We need a complete SWPPP per the State requirements. SWPPP needs to be submitted and reviewed prior to the approval of the subdivision and or prior to construction.

**IMPROVEMENT PLAN**  
DEVELOPER: CRAIG STANDING PH: 801-540-4989

**JACQUELYN ESTATES CLUSTER SUBDIVISION PH 1**  
LOCATED IN THE N.W. 1/4 OF SECTION 29, T.6N., R.2W., S.L.B.&M.  
WEBER COUNTY, UTAH

**NEW SEWER LINE FROM 2200 SOUTH ST TO JACQUELYN DRIVE**

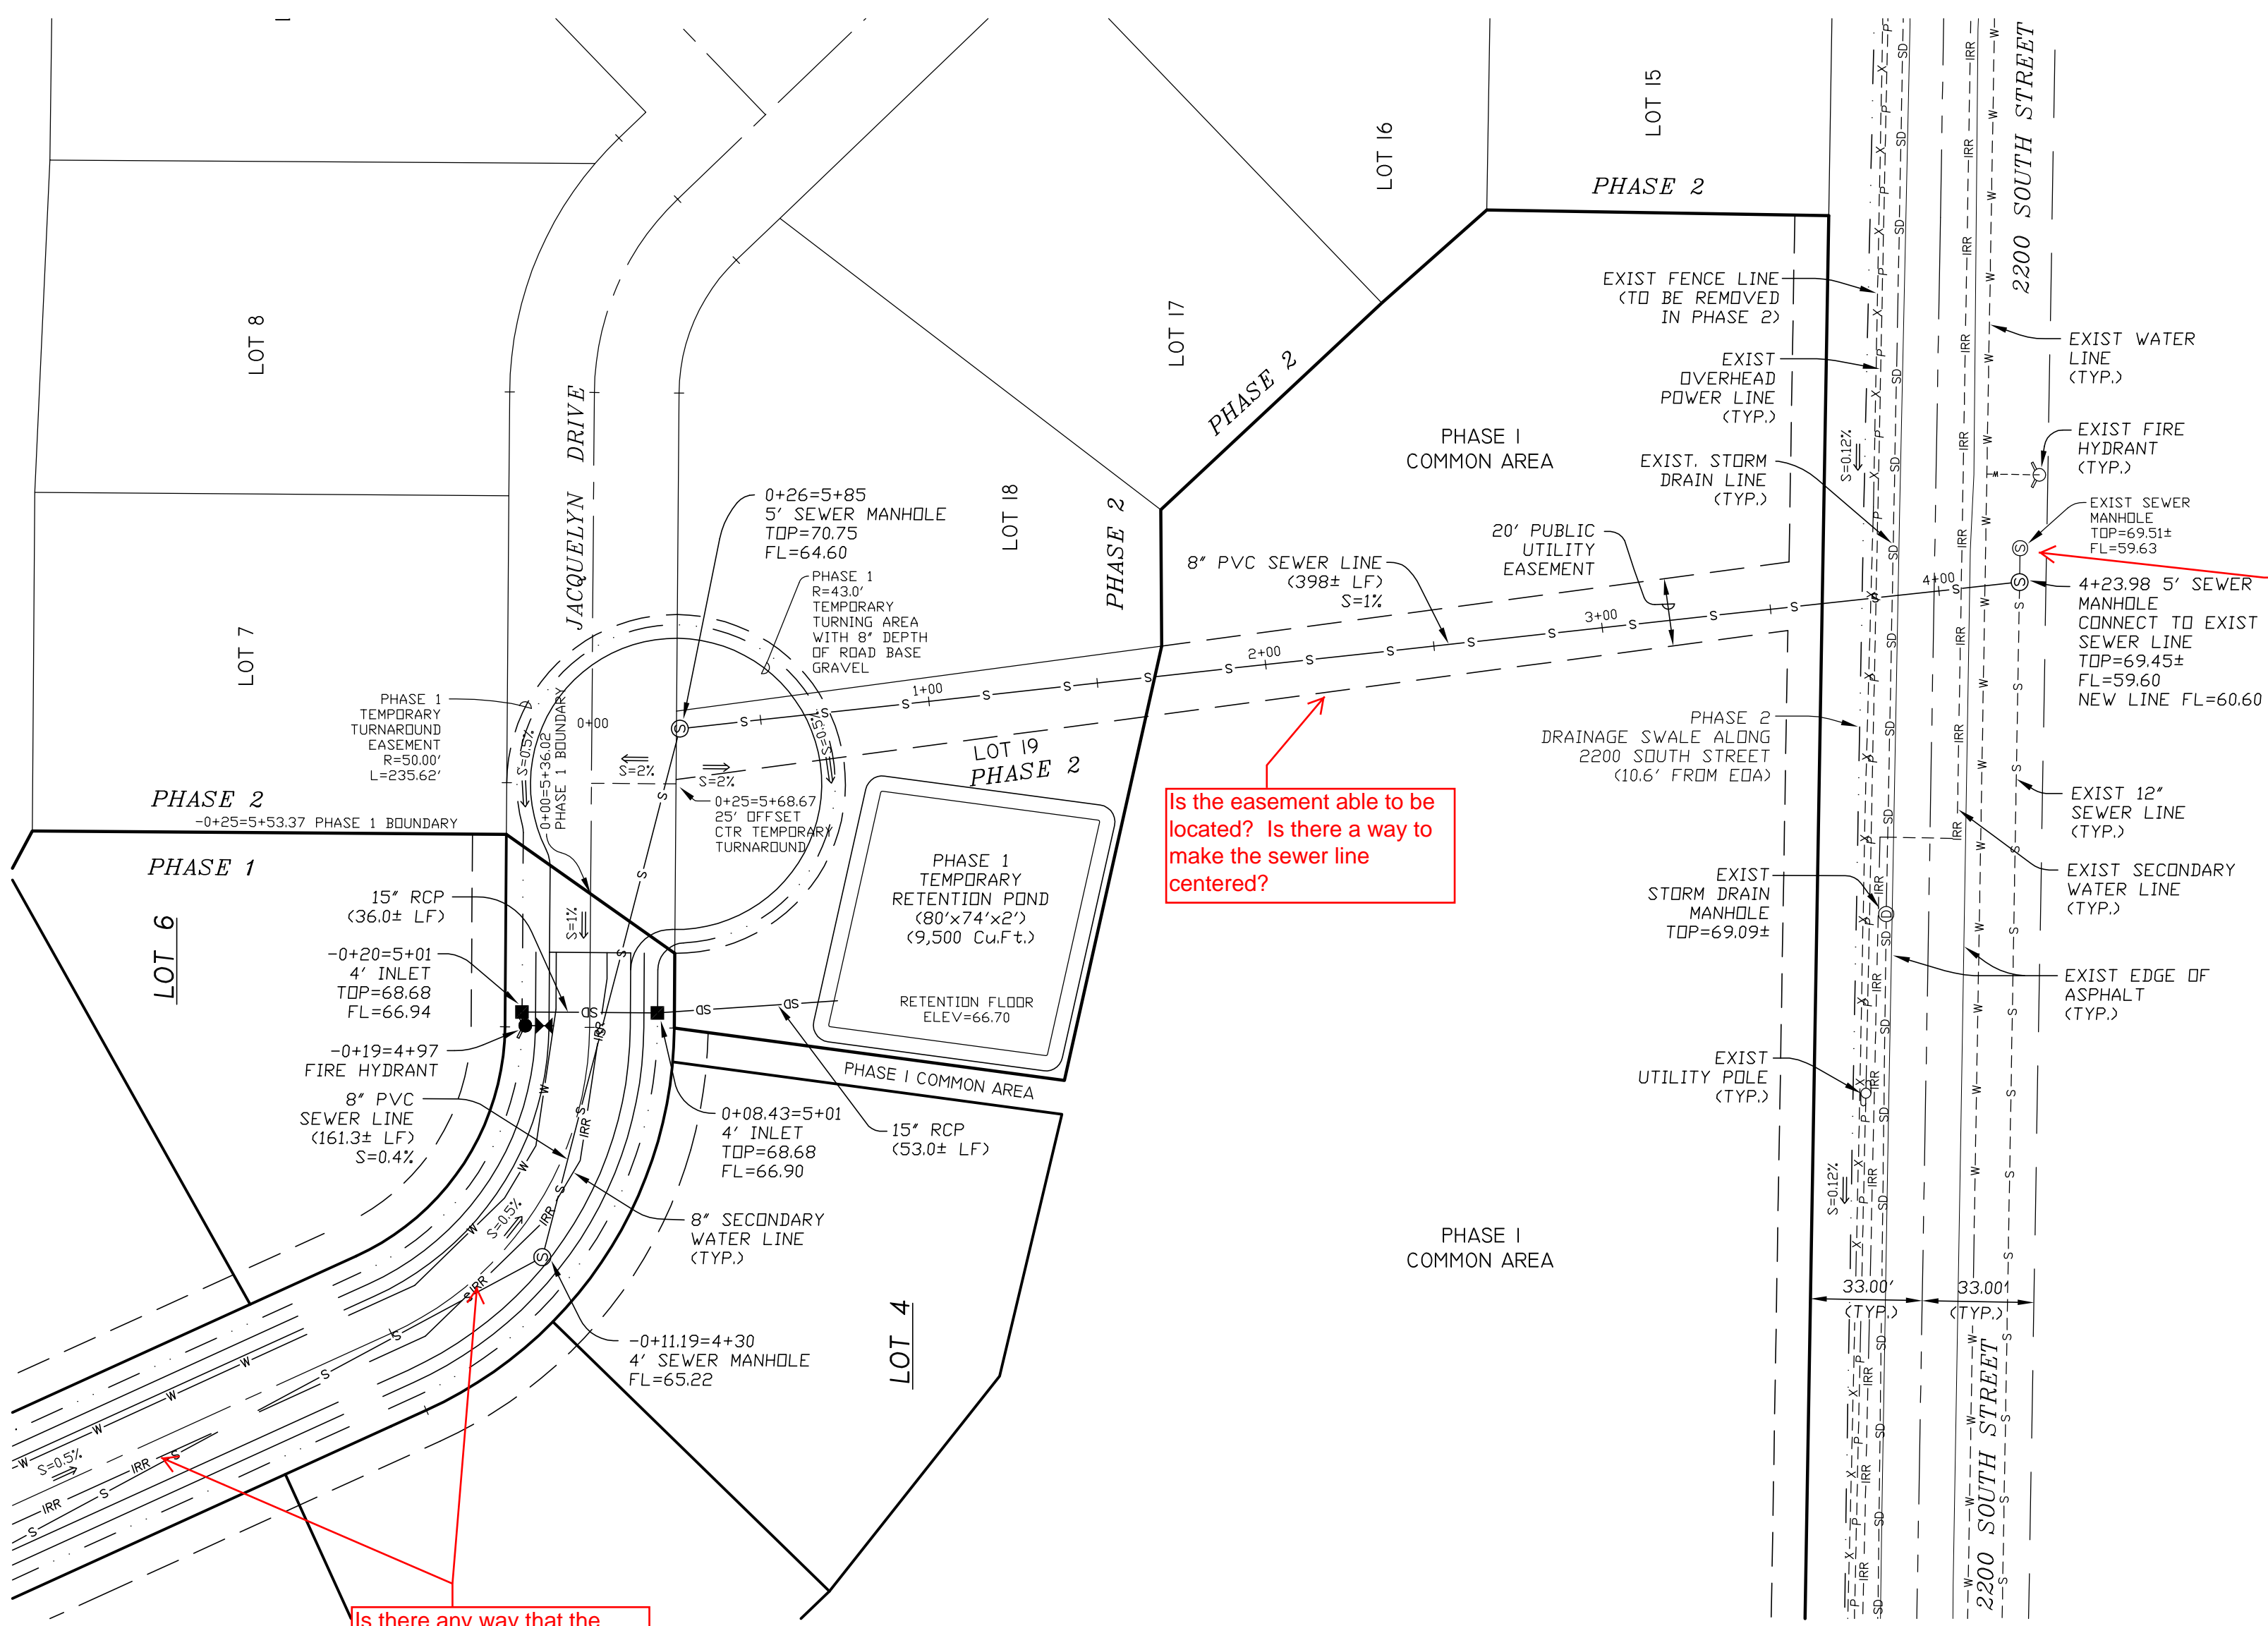
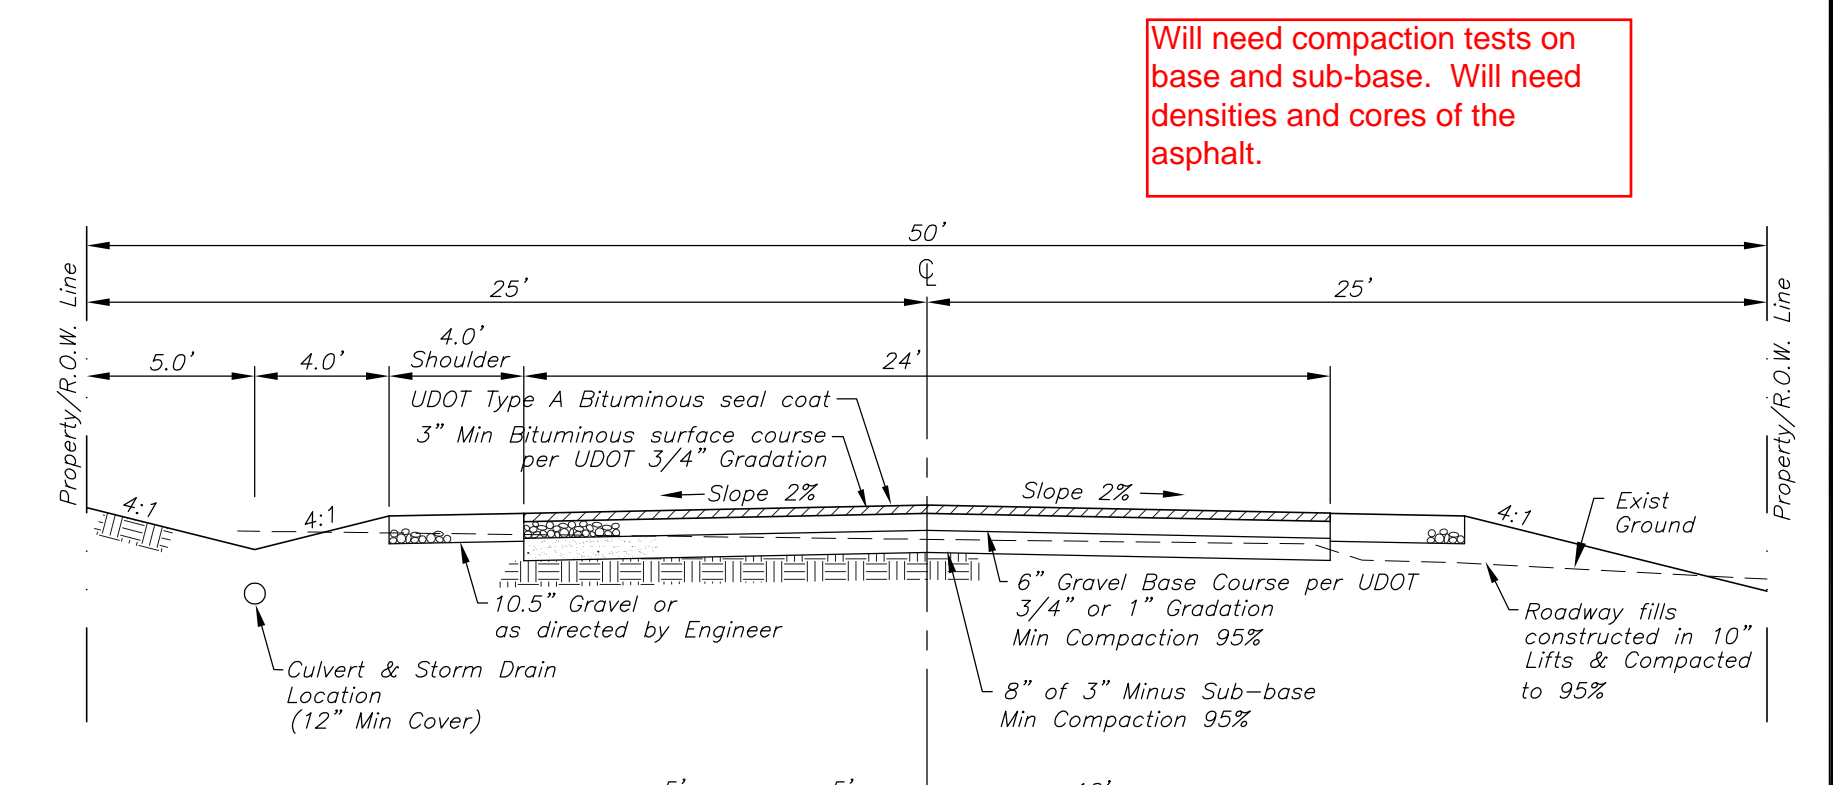
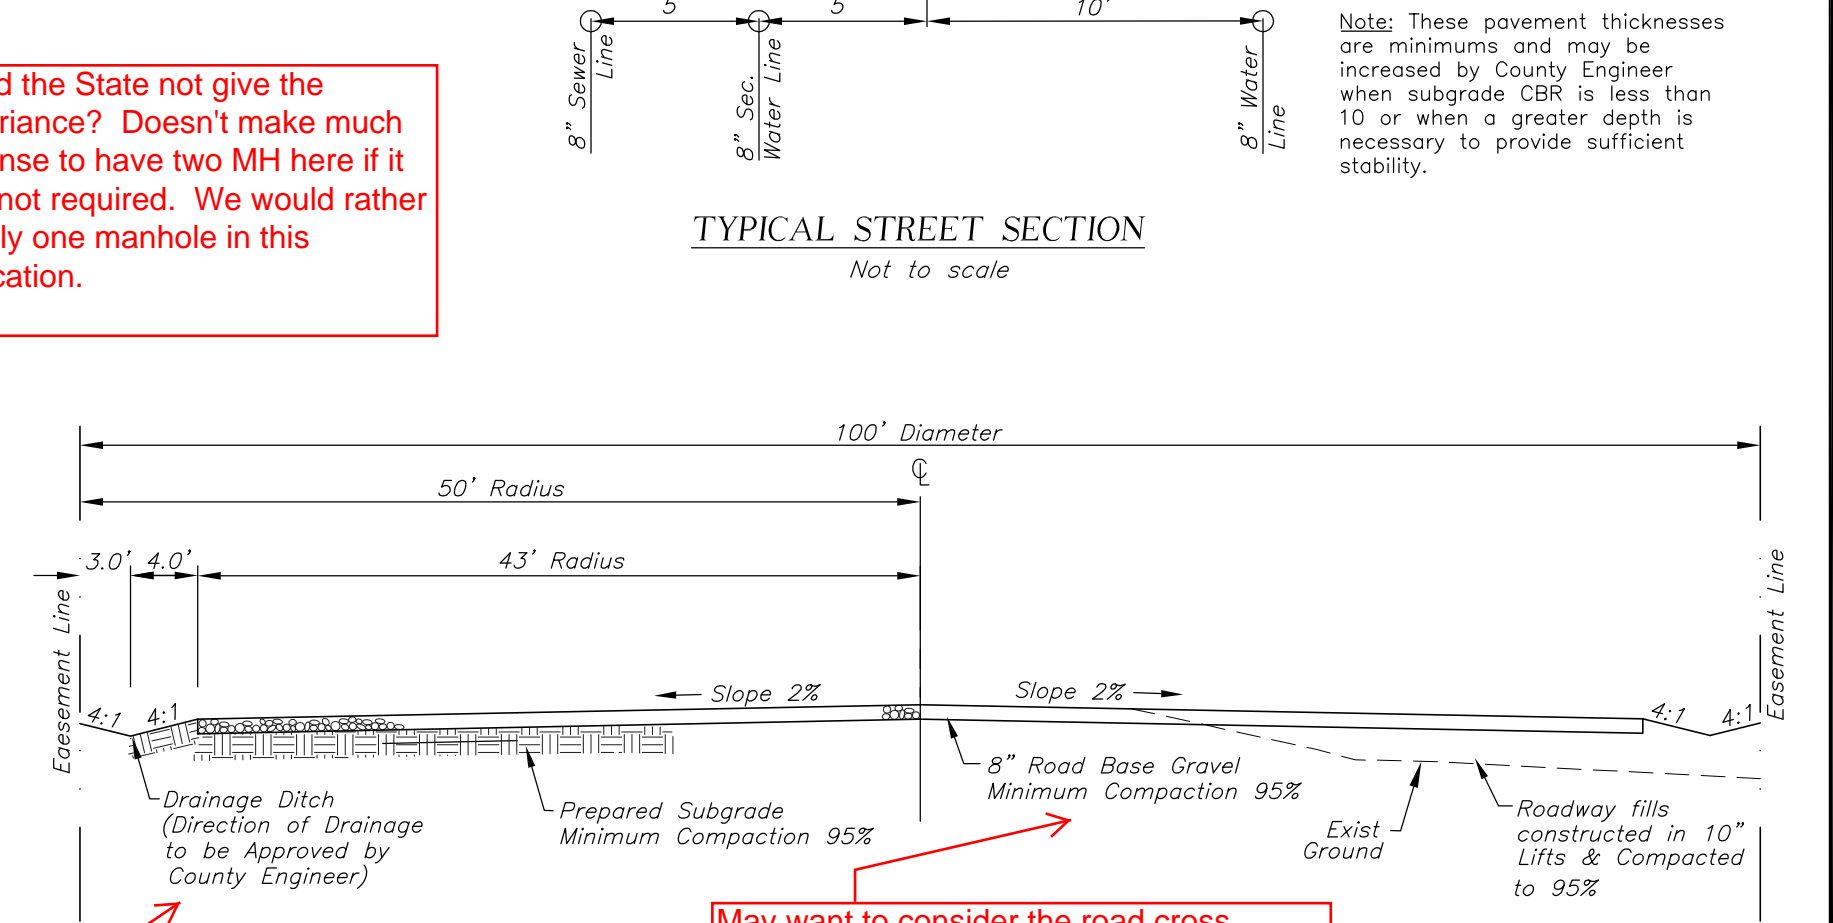
Did the State not give the variance? Doesn't make much sense to have two MH here if it is not required. We would rather only one manhole in this location.

Plan shows direction of drainage. Does this not work?

TYPICAL GRAVEL TRAIL SECTION  
Not to scale

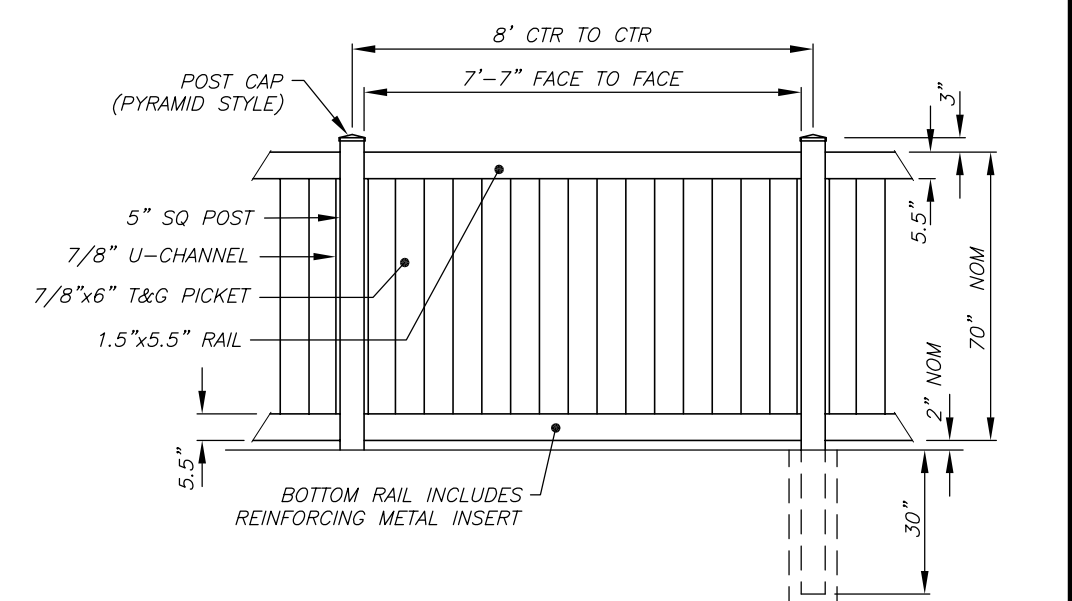
May want to consider the road cross section for the future phase.
